**International Design Competition for
Gyeongsangbuk-do Human Resource Development Institute Relocation Project
- Inquiries and Responses -**

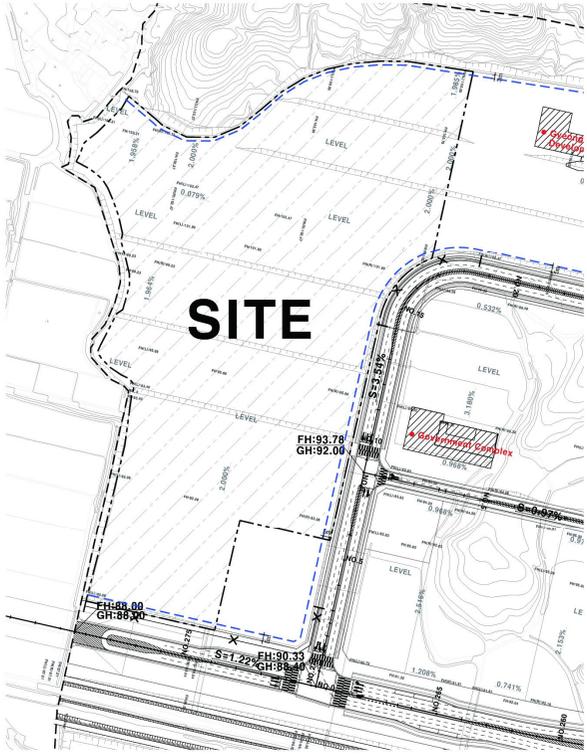
<p>31</p>	<p>Is it possible to provide the application method for the setting of the building limit line in the site division line (734 units, 735 units) or the data indicating the building limit line?</p>	 <p>----- 건축한계선 (Limit Line of Structure)</p> <ul style="list-style-type: none"> - It is included in the provided material. (02 SITEMAP-Limit Line of Structure)
<p>32</p>	<p>Is it possible to provide scale (persons, area) for future extensions (dormitory, etc.)?</p>	<ul style="list-style-type: none"> - There is currently no plan, but various proposals can be made according to the participant's design intention.
<p>33</p>	<p>Is it possible to provide materials related to the training program of the Human Resources Development Institute?</p>	<ul style="list-style-type: none"> - Refer to the design guidelines.
<p>34</p>	<p>Is it possible to provide data on traffic impact assessment?</p>	<ul style="list-style-type: none"> - No data provided separately
